**ADDENDUM 1
CSP 23-26
GYMNASIUM ADDITIONS/IMPROVEMENTS FOR
BETTS & KENNEDY ELEMENTARY SCHOOLS
November 9, 2022**

Addendum Number 01

Edinburg CISD Gymnasium Addition & Renovation Project –
John F. Kennedy Elementary & Melissa Dotson Betts Elementary
CSP 23-26

PBK Project No.: 220019

A-301

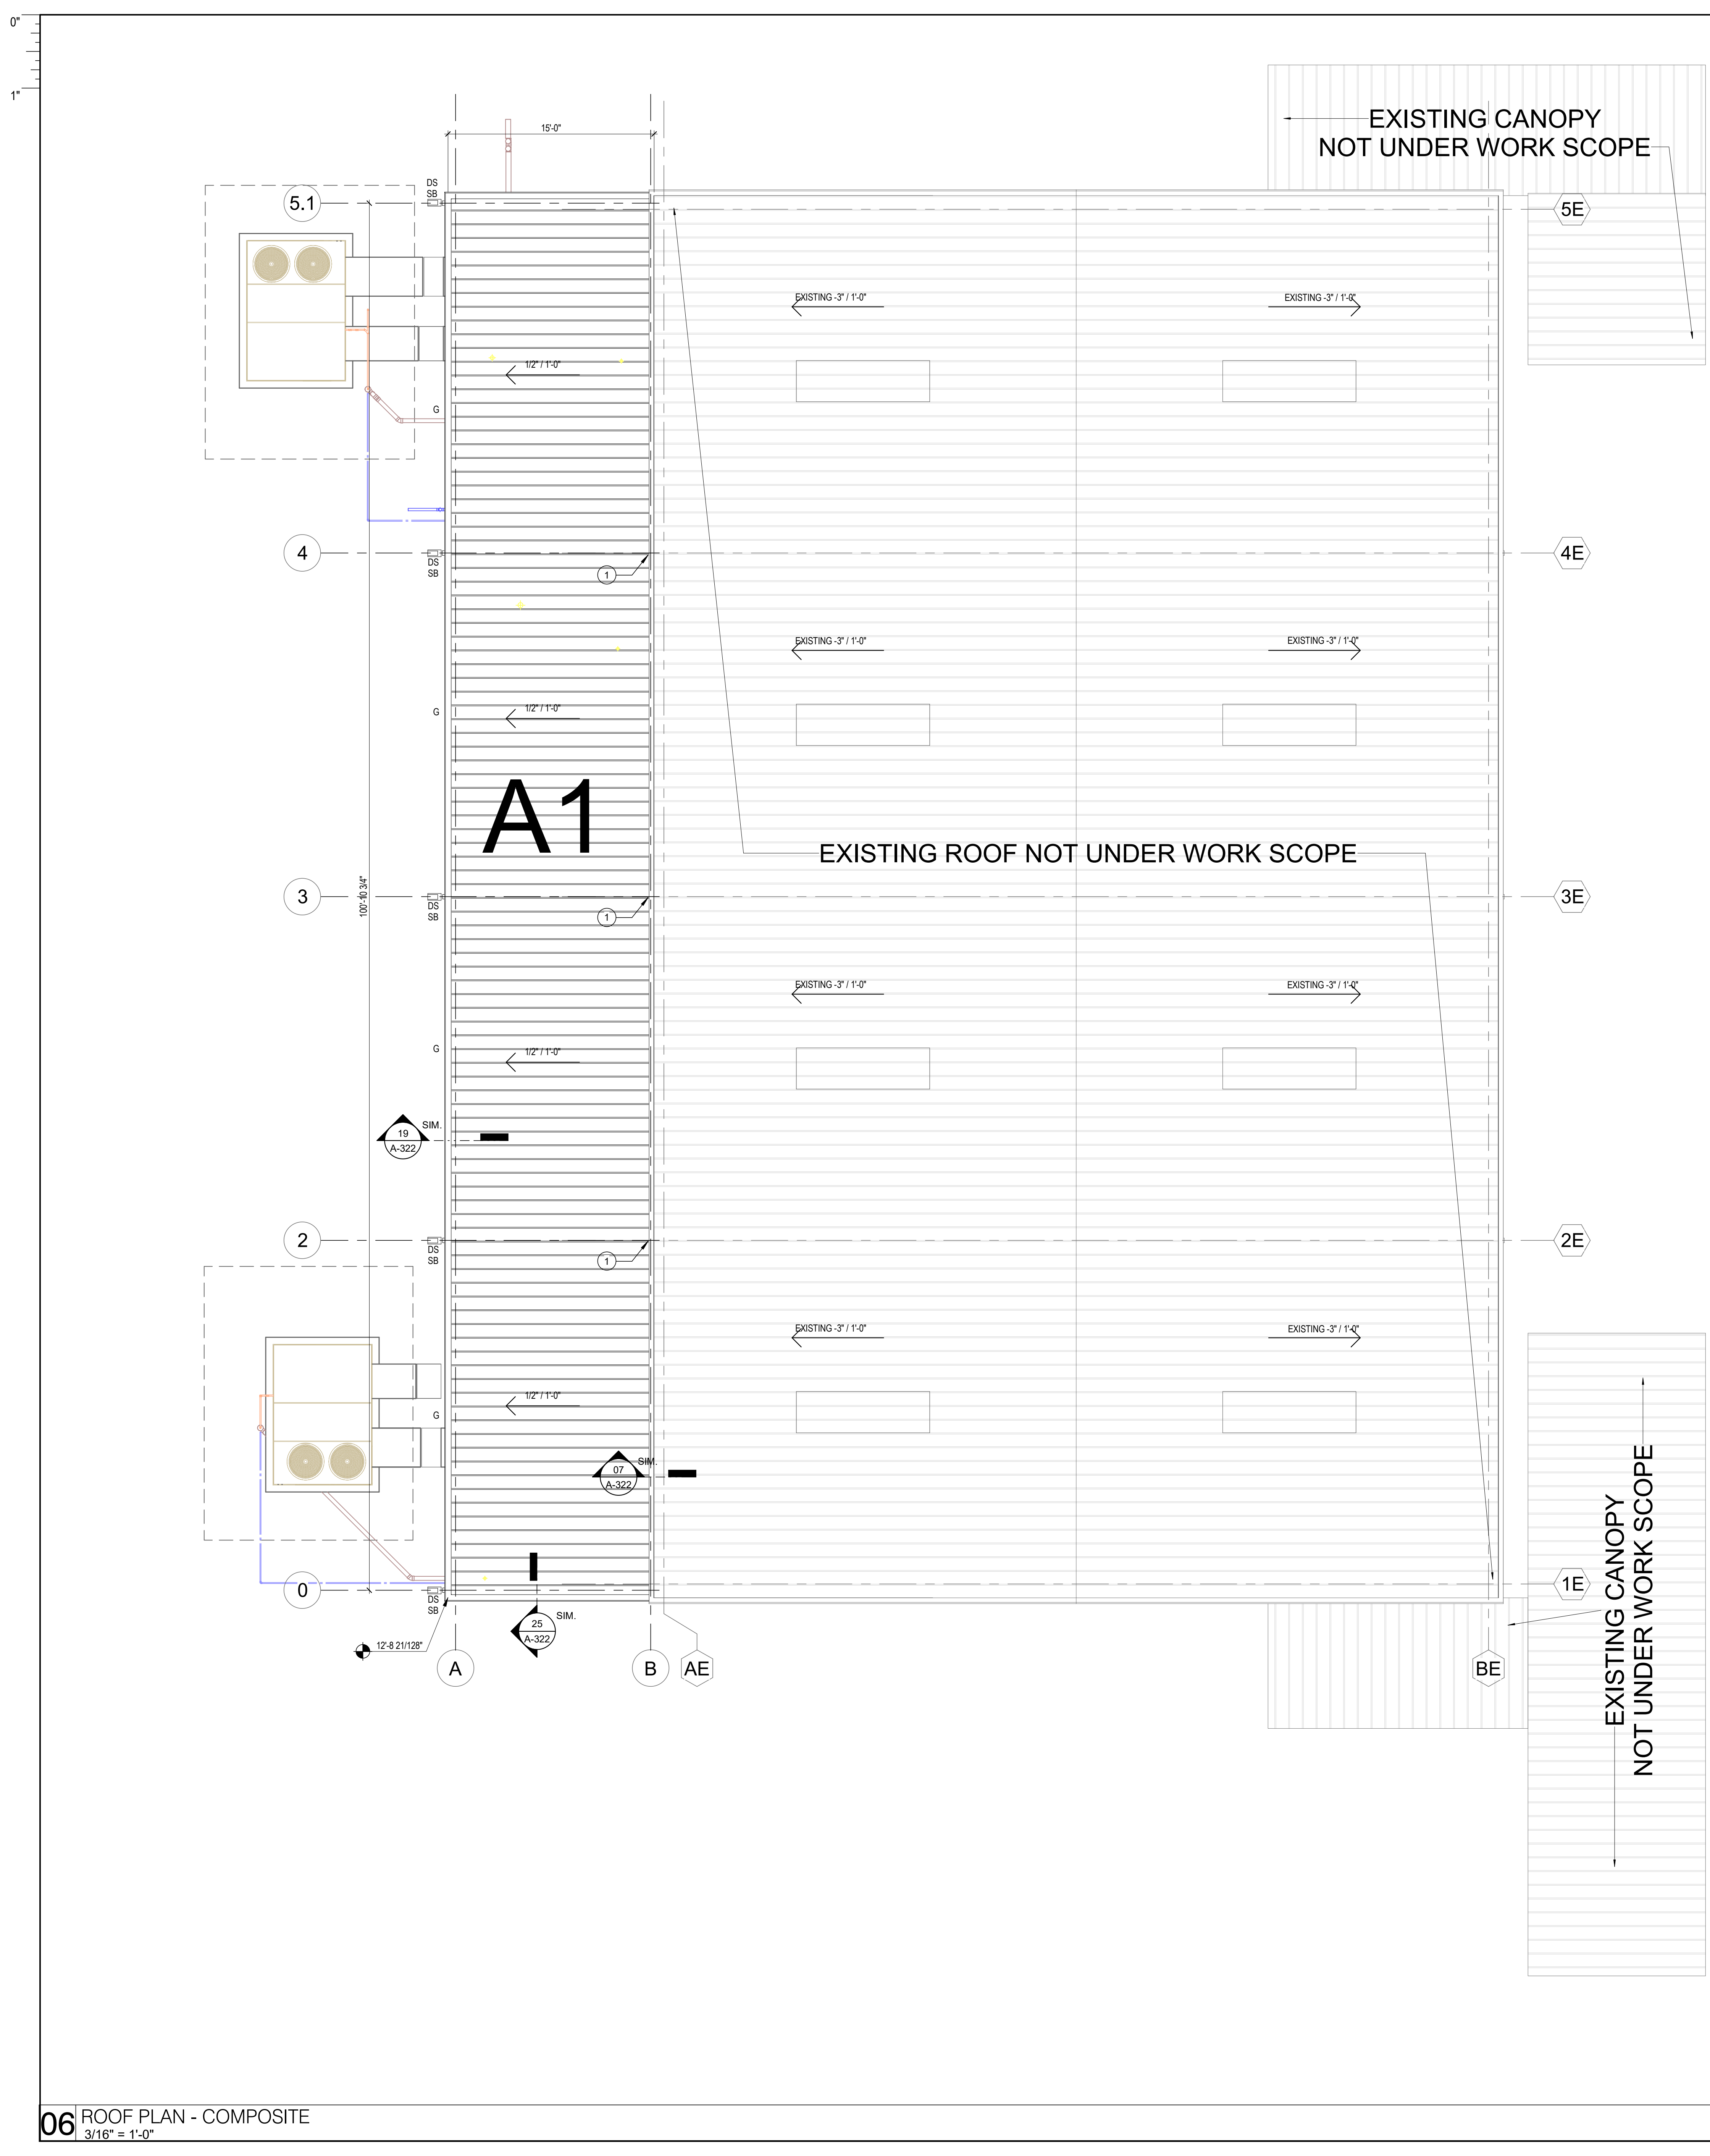
- Item No. 10:** Sheet A-301: ROOF PLAN – COMPOSITE. Delete in its entirety. (John F. Kennedy Elem.)
Replace with revised sheet A-301. Roof Metal – Nomenclature details have been updated.

E5.01

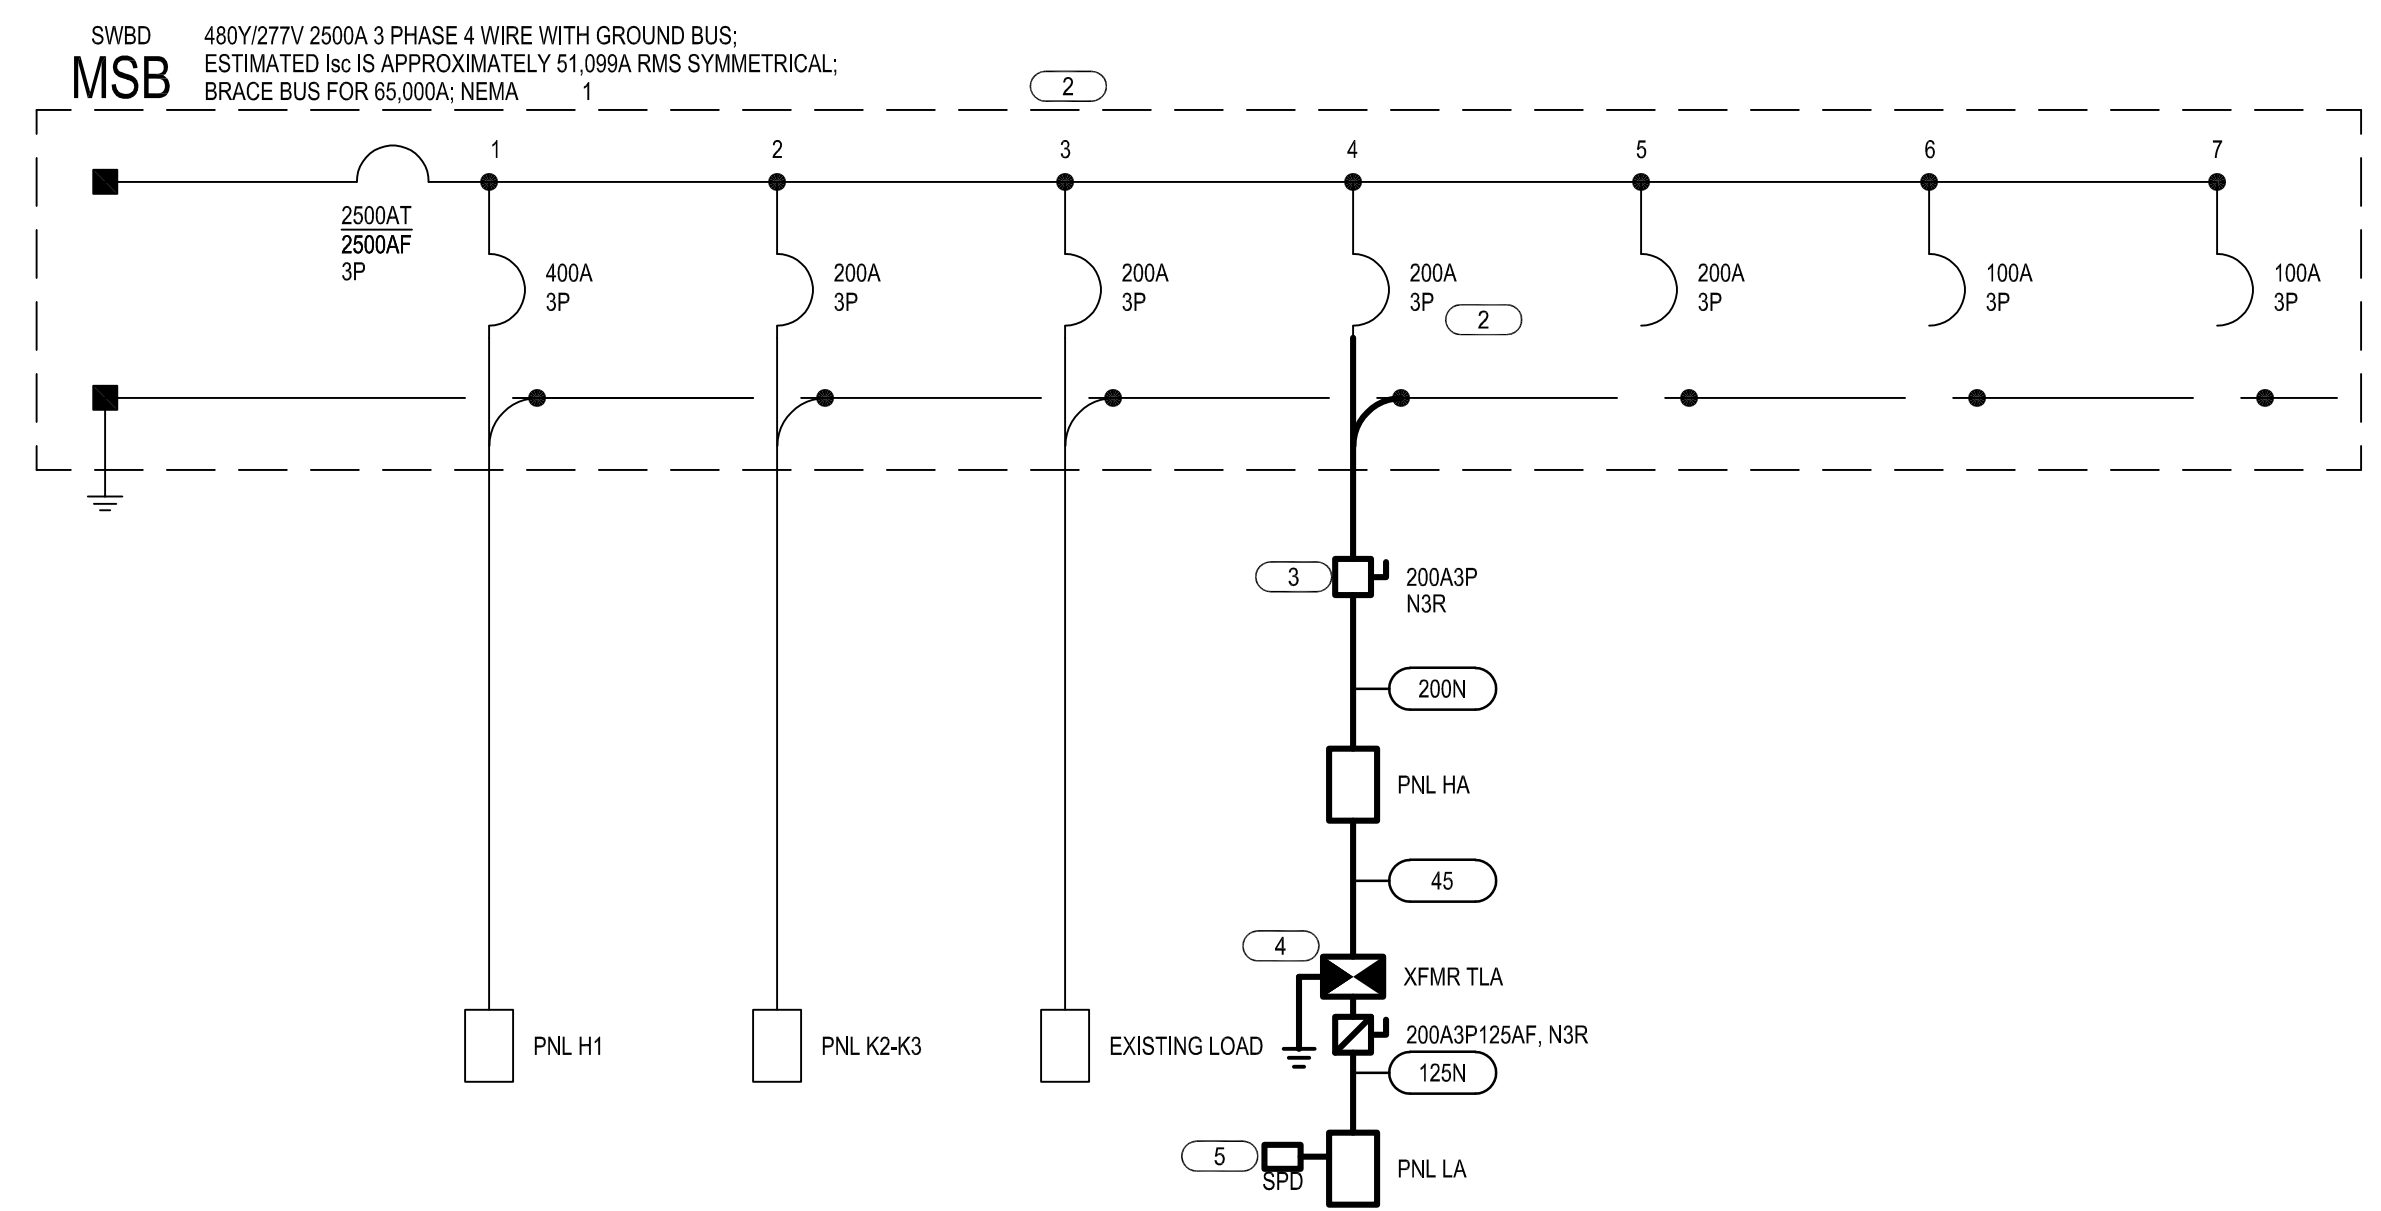
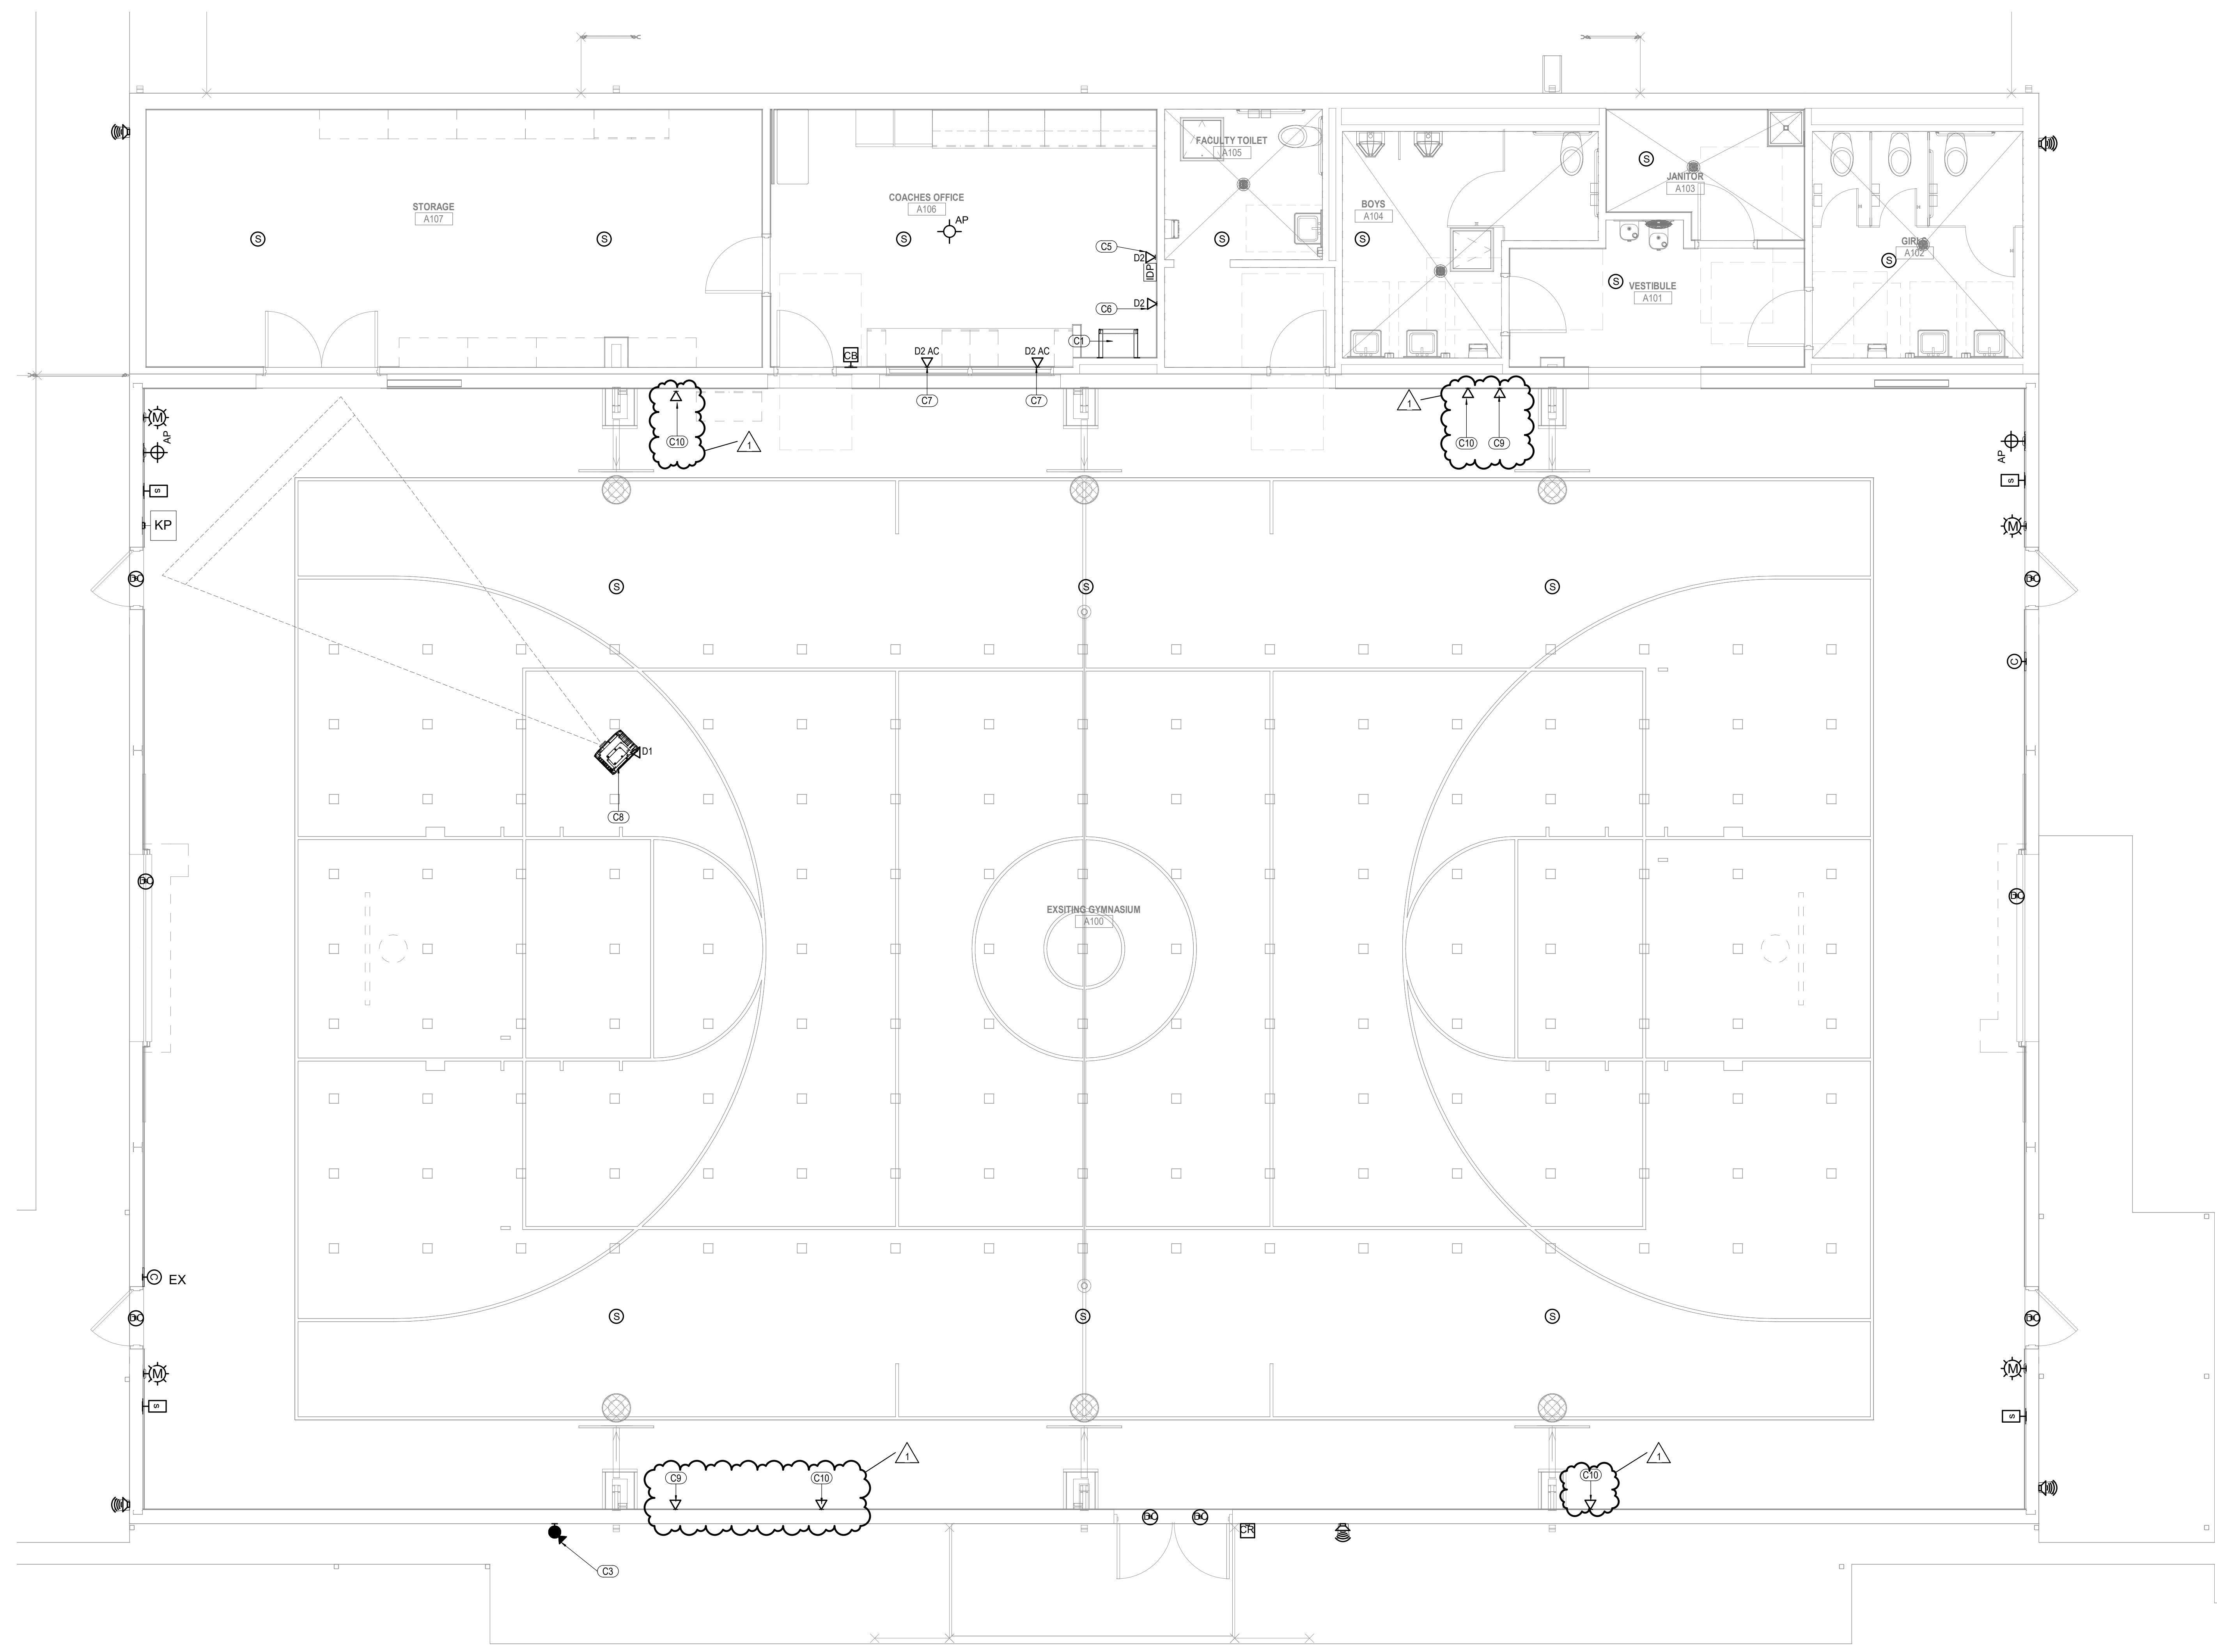
- Item No. 11:** Sheet E5.01: ELECTRICAL ONE LINE DIAGRAMS. Delete in its entirety. (John F. Kennedy Elem.)
Replace with revised sheet E5.01. Added Feeder / Branch Circuit Schedule.

1: The issue at hand can be found on either the Betts or Kennedy Electrical plans. As per E5.01, the one-line diagram shows feeder circuits from a Disconnect to Panel HA as (200N), from Panel HA to XFMR TLA as (45) and from Disconnect to Panel LA as (125N). There is no schedule to be found to indicate the wire size/conduit to be used. Please advise as soon as possible please. Thank you

- Please see attached sheets E5.01 for both JFK & Betts Gyms for added information on the Feeder/Branch Circuit Schedule.
